KENWOOD

ASB-1032

Service Bulletin

Subject: TS-450/690S Low Mic Gain w/DSP-100

IF Unit (X48-3090-XX)
Foil Side View

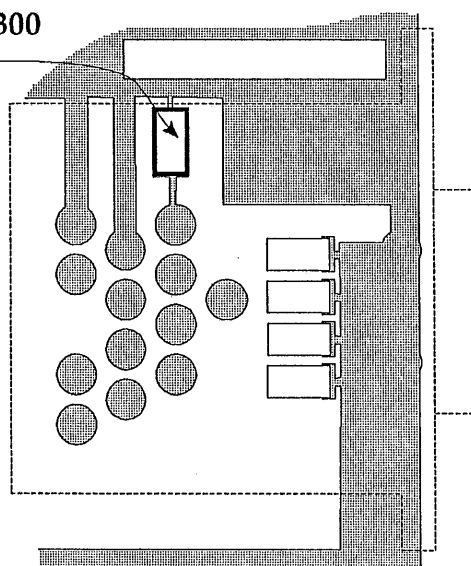
Proper microphone gain/ALC readings cannot be obtained unless the user adjusts the TX GAIN potentiometer on the rear of the DSP-100. This irregularity is caused by an instability of the DSP-100 MIC amplifier (IC-5).

Remove capacitor C200 from the IF unit on the transceiver, and replace it with R300, a chip jumper wire.

Replace with R300
(R92-0670-05)
